ECLIPSE
Engineering Bulletin
No: EB-0501

Product : STG-1

Topic : C19 polarity in 9169/0002 PCB assembly

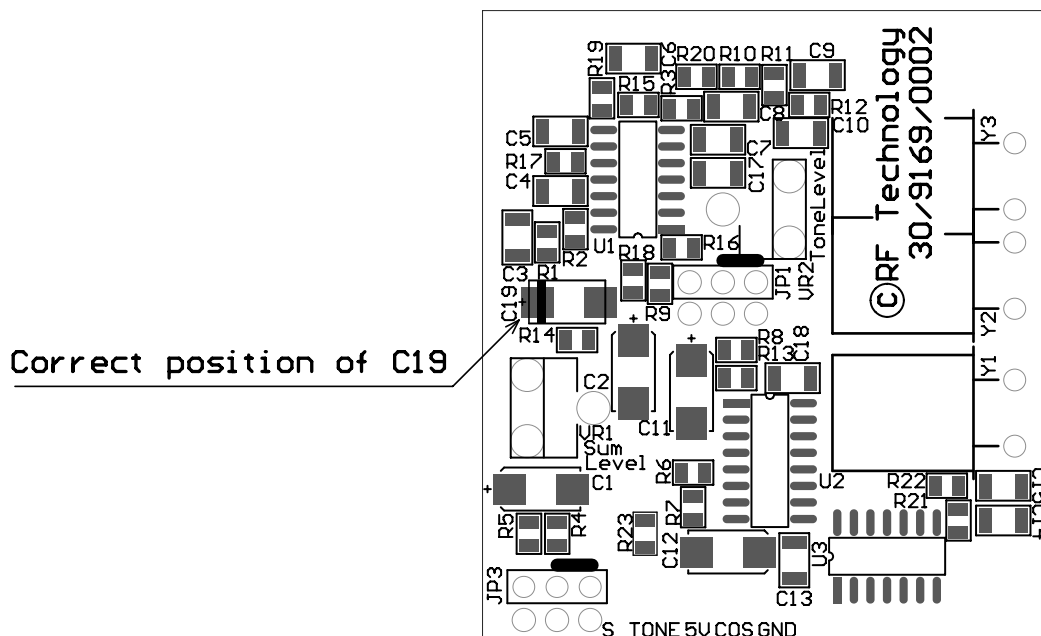
In revision 2 of RF Technology's STG-1 (Status Tone Generator) module, the position of 10uF electrolytic capacitor, C19 was reversed on PCB. It causes distortion at the receiver line/direct audio output.

The affected module can be identified by the PCB version number: 30/9169/0002. If audio distortion problem was found with STG-1 module, check the position of C19, refer following diagram to fix the problem. Note the bar marking (positive) is closest to the PCB edge.
